Backfeed voltage during 2, 3 and 4 pair operating modes

May 2018
Yair Darshan
Rev006

Objectives

- To investigate the effect of excluding backfeed requirements for 3-pair mode.
- To check if and in which parts, the IEEE802.3bt D3.4 need to be updated as a result.

Problem #1 with the existing text vs. existing legacy and pre 802.3bt standard PDs implementations

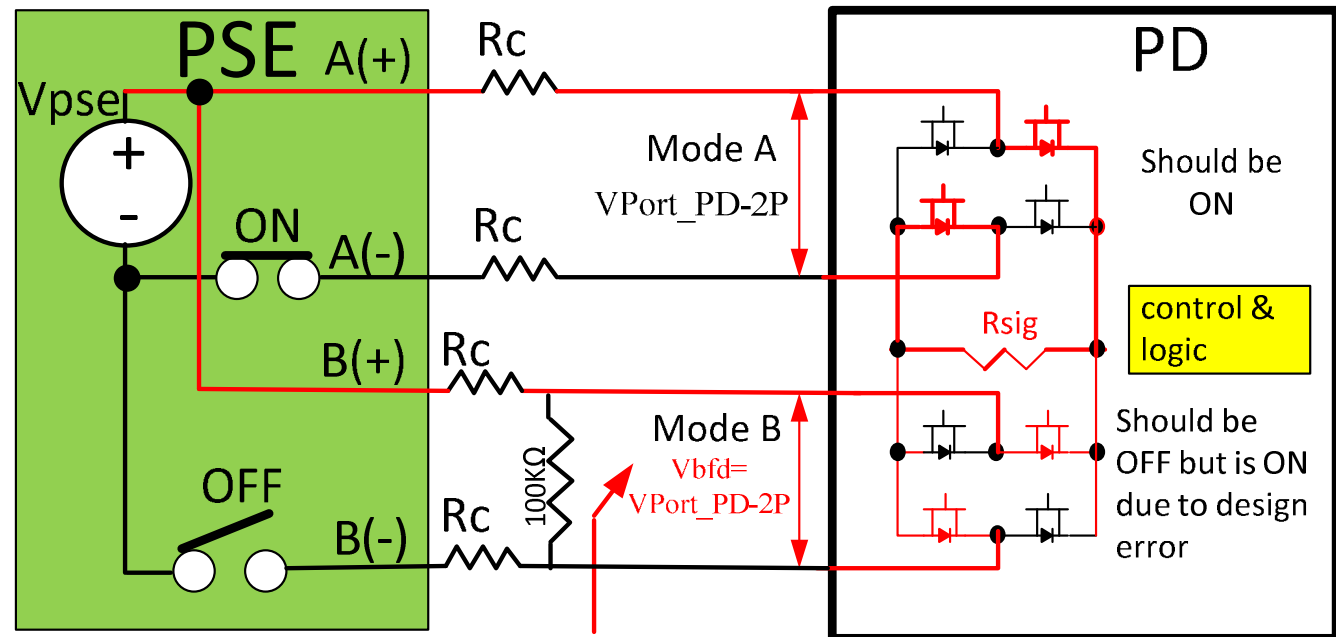
- Some **Ideal diode bridges** in the market used with Type 1 and 2 PDs and pre-802.3bt SSPDs will fail to meet the backfeed requirement when operated in 3-pair mode¹.
- in most 4-pair PSE implementations, all positive leads are tied together and only the negative leads are switched. This results in 3-pair mode when a 4-pair PSE is powering over 2-pair

Note 1: Found during the last Plug Fest when pre-standard 802.3bt PDs where connected to pre-standard 802.3bt PSEs. Designers didn't verify that these specific implementations doesn't 100% match diode bridge behavior (which doesn't have the backfeed issue in 3-pair).

Should we include (limit to 2.8V/28uA) or exclude (allow up to 57V with ILIM-2P) V_{bfd} requirements for 3-pair mode?

New issues – Detection pollution

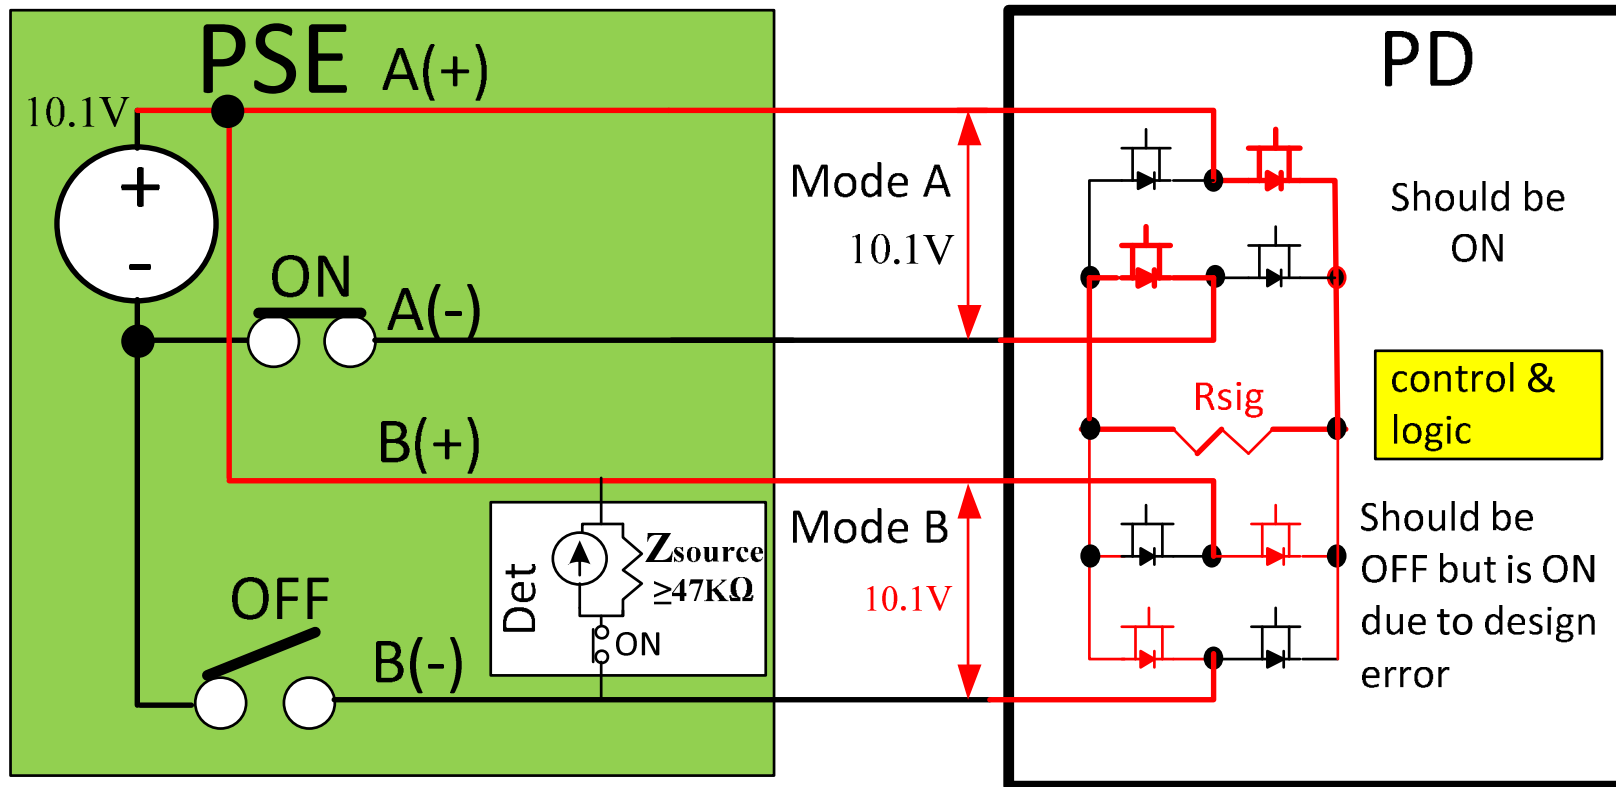
Why to include backfeed in 3-pair for up to 10.1V?

- Detection will be polluted if we allow ideal diode bridge to be ON in SSPDs during detection by the other alternative Z_{source} (Figure 145-19) in the detection circuitry.
- Z_{source} will be in parallel to R_{sig} .
- Solution: To require meeting backfeed for at least 10.1V (Preferred 20.5V for classification or better 30V since detection open voltage can reach 30V. See next slide).

New issues – Classification pollution

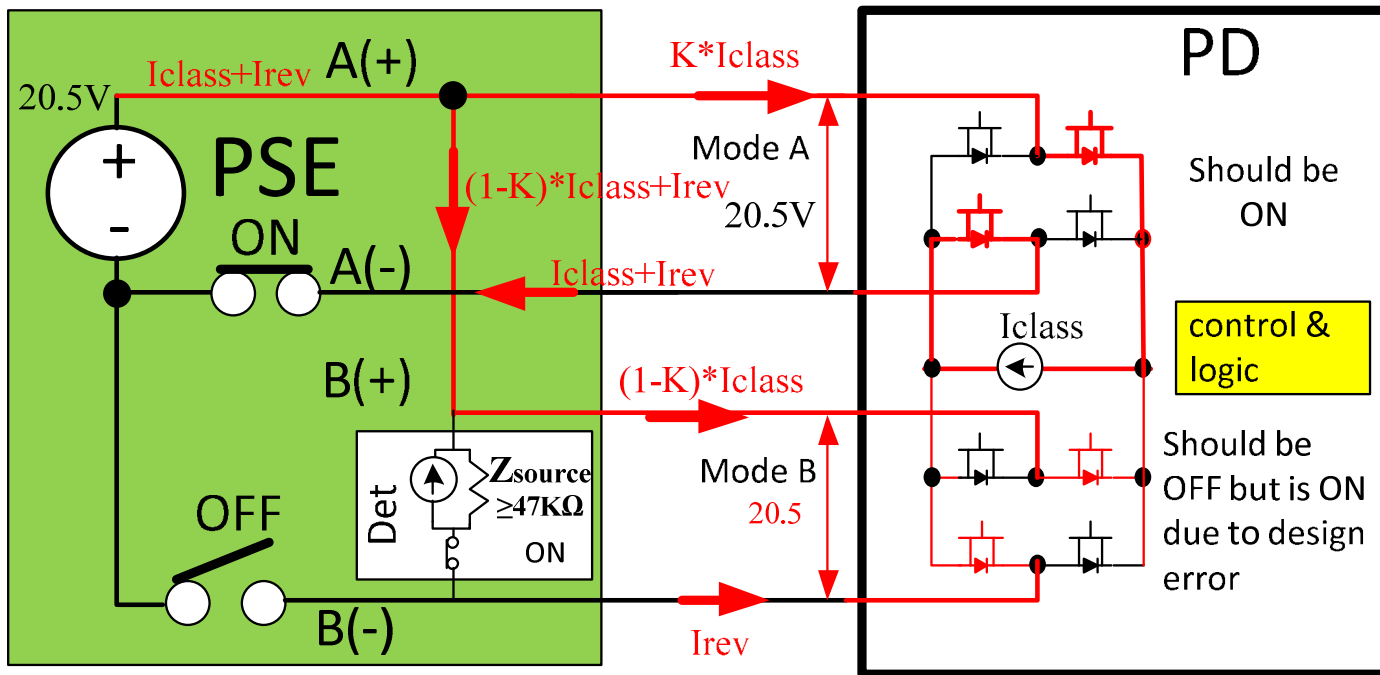
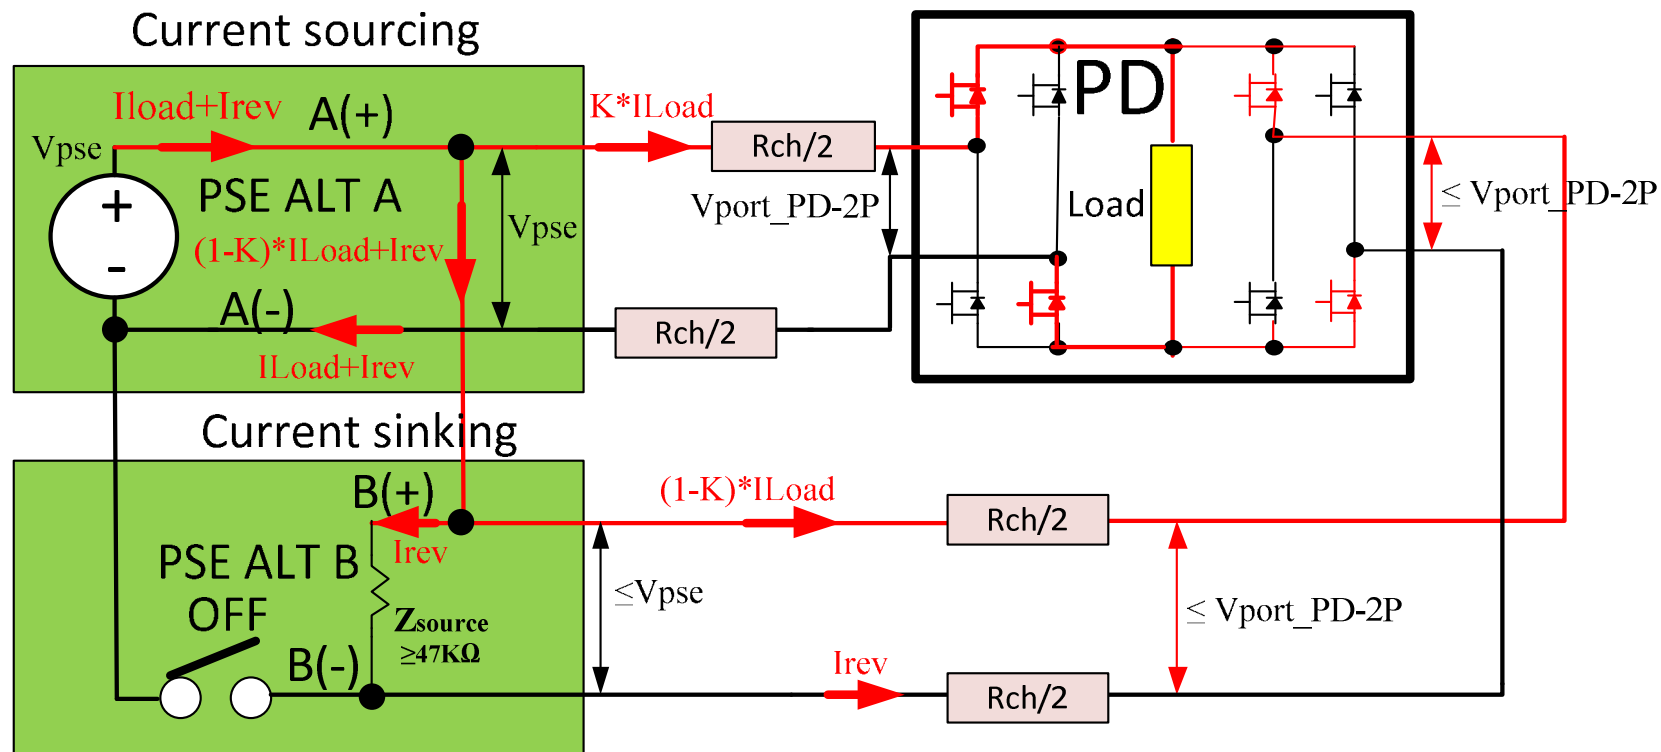
Why to include backfeed in 3-pair for up to (20.5V+margin?)

- In SSPDs we have single classification signature
 - Classification current may be changed by $20.5V/R_{source_min}=0.436mA$ (or I_{rev}) which will require tighter accuracy measurement
 - e.g. instead of 3mA margin between class 0 to class 1 and class 1 to class 2 we will have to meet $(3mA-0.436mA)$ margin (and it is worse since $I_{rev}=1.3mA$ max)
- If the legacy ideal diode bridges ALSO violates backfeed during the 30V range then it is a major design mistake and we should not allow it!

To require meeting backfeed in 3-pair for at least 20.5V+margin (preferred 30V. See next slide)

Source current vs.. sink current – proposed text

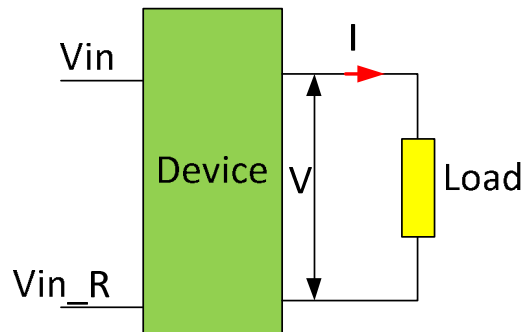
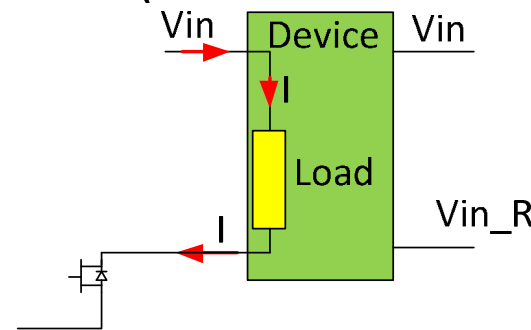
This text was deleted since Table 145-20 doesn't address I_{rev} and doesn't supply any other relevant info with the current order of the text description.

This text was deleted since it means that if the voltage is higher we can draw more current...

When a 4-pair capable PSE provides power in 2-pair mode, whereby two pairs are connected to the positive VPSE, and one pair is connected to the negative VPSE, a single-signature PD may reflect a voltage of up to VPSE back onto the unpowered pairset. See 145.3.8.8. The PSE shall not source a current higher than I_{rev} on the unpowered negative pair, as defined in Table 145-20, on the negative pair of a pairset when the voltage of that pairset is equal to or lower than the voltage of the other pairset.

Annex D: List of issues to resolve/investigate

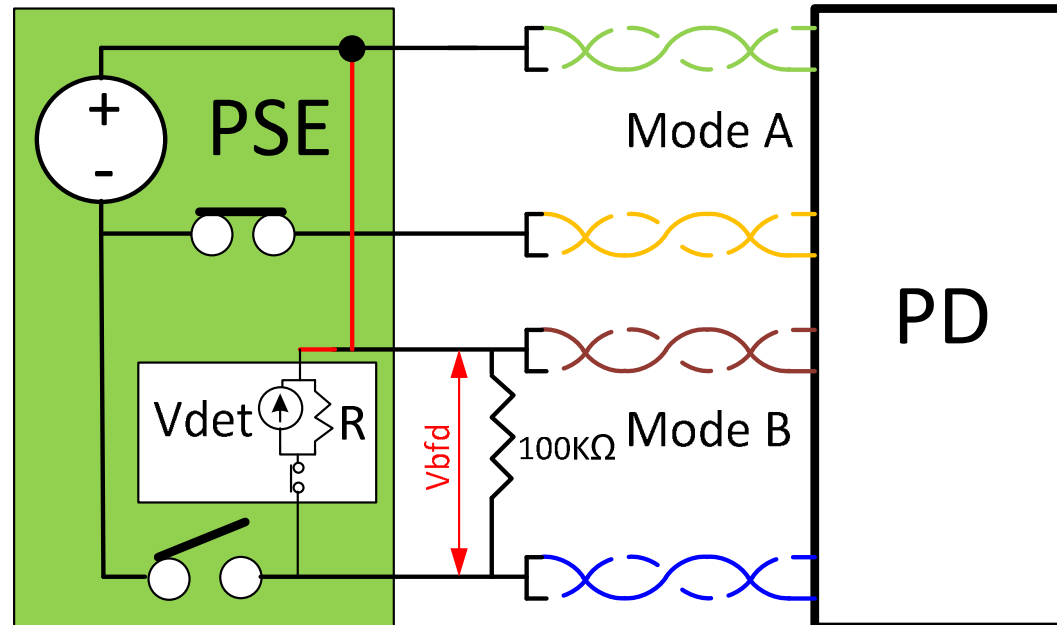
- Test conditions: Applying high backfeed voltage (VPort_PD-2P) to the unpowered pair of a 4-pair PSE when connected **to an ideal diode bridge from a schematic that was supplied to me¹**, in the following cases and checking for:
 - damage to existing 4-pair PSE detection circuitry that was used to see up to 30V during detection and backfeed voltage up to 2.8V and now may see backfeed voltages up to 57V.
 - PDs using wall adapters. If excluding 3-pair, PSE or PD or bot will be damaged since maximum voltage and current are not specified.
 - Damage or interoperability issues in a typical Endspan/Midspan configuration
 - When a PSE is connected to a SSPD through crossed cable: Damage to the detection diode across the PI due to reverse polarity¹?

When a PSE is connected to SSPD through crossed cable: safety (>60V) between the two modes¹?

- increasing PSE susceptibility to cross leakage current issues that will prevent successful detection on adjacent pairs/ports (now leakage may be higher by $57V/2.8V \approx 20$)
- Effects of backfeed violation on detection and classification
- **Other? Group/system vendors need to check for other use cases to ensure we are not creating problems in such late stages of the standard.**

Annex F: Endspan/Midspan configuration

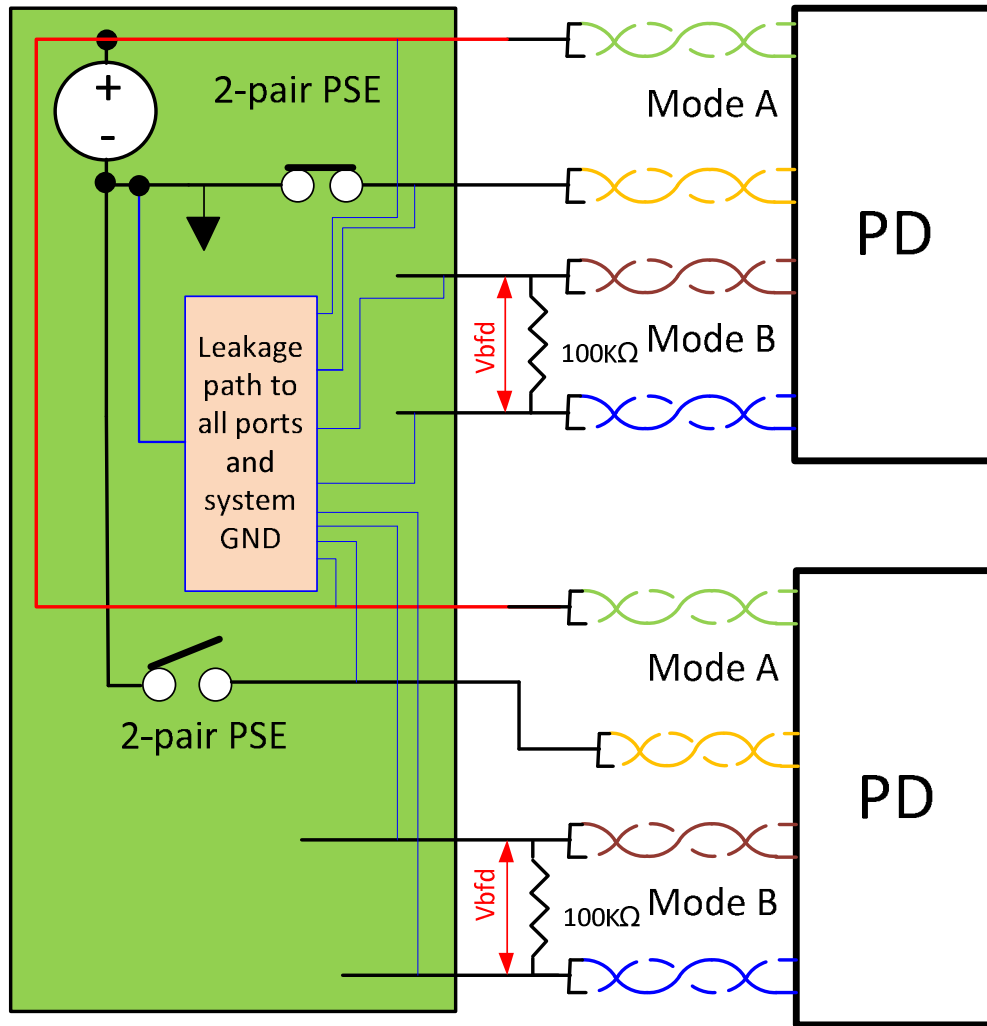
- Since a Midspan, when connected to Endspan, breaks the DC continuity over at least one positive pair, ***the 3-pair mode is avoided*** which results in true 2-pair mode operation, which meets the backfeed requirement.
- **Conclusions: No issues with Endspan/Midspan configurations if we exclude backfeed requirements in 3-pair mode.**

Annex J: Addressing dual-signature PDs

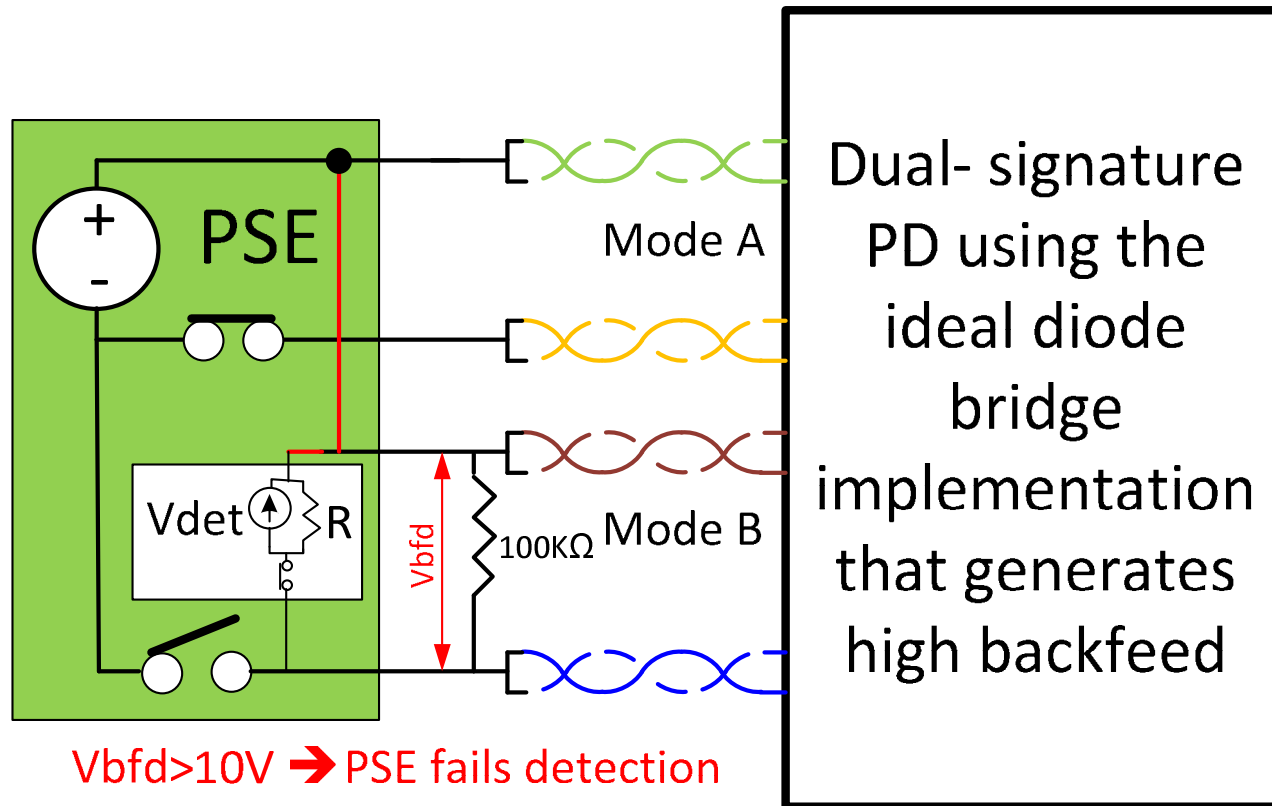
- The current text looks like it covers both single-signature and dual-signature PD, however dual-signature PDs must meet backfeed for any valid configuration in Table 145-20 (2-pair, 3-pair and 4-pair) and we need to ensure this in the final text of backfeed, if it is going to be changed.

If excluding backfeed from 3-pair, to do it only for SSPD and add new text to include backfeed requirements for dual-signature PDs in 2-pair, 3-pair and 4-pair modes.

Annex K1: PDs with wall adaptor

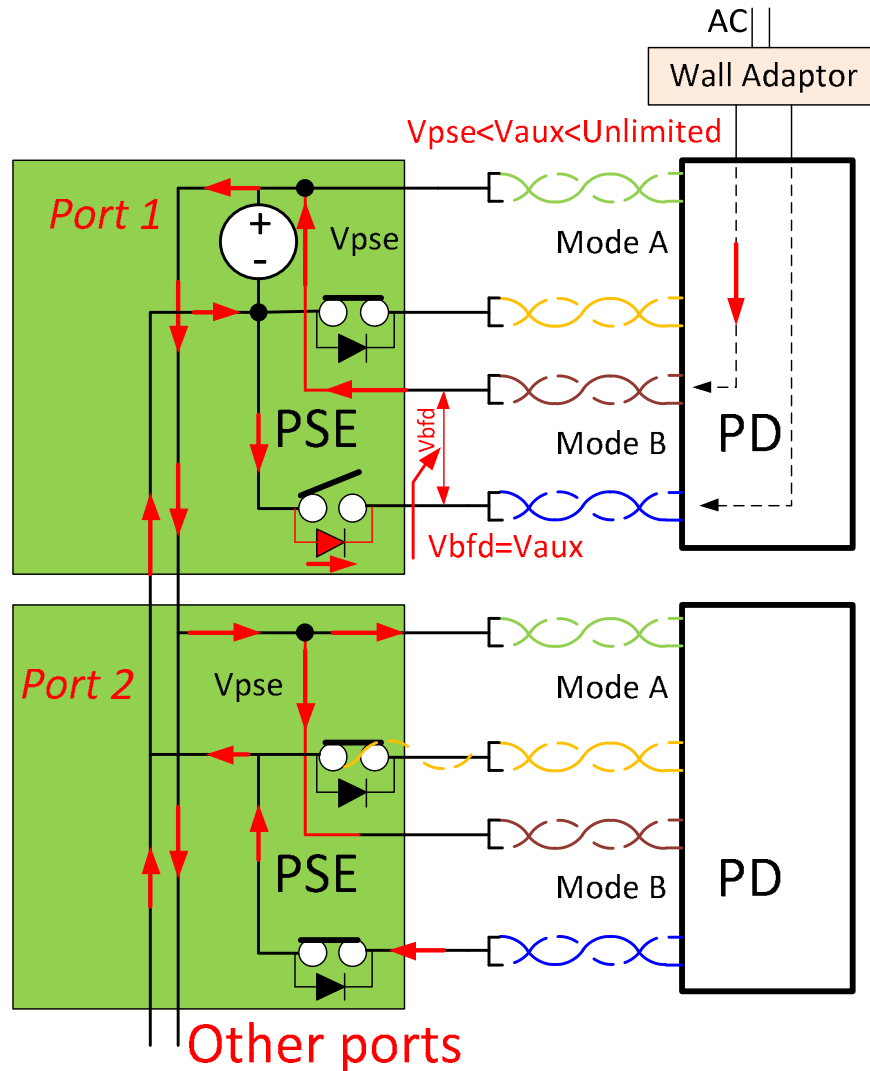
- The concern is that violation of PD back feeding has the same results as if PD is sourcing power which is ***not acceptable!***
 - PDs with aux power supply are allowed by the standard
 - Their maximum voltage and current limits are not specified
 - ***The concerns are:***
 - Voltage > V_{pse_min} . PD aux power supply will replace PSE PS and power all the ports and will damage the PD aux power supply
 - Voltage > 57.
 - It will damage PSE
 - Violate the safety spec (SELV).
 - PD aux power supply will replace PSE PS and power all the ports and will damage the PD aux power supply.
 - See problem and solution next slide

- Risk of damaging:
 - PSE (If $V_{aux} > 57V$)
 - PSE MOSFET body diode of port #1 ALT B
 - PD (Aux supplies all the power to the 1KW PSE load....)
 - Other PSE connected instead of Aux

Need to keep the requirement that PD shall not source power and clarify in additional text that backfeed is not sourcing power.
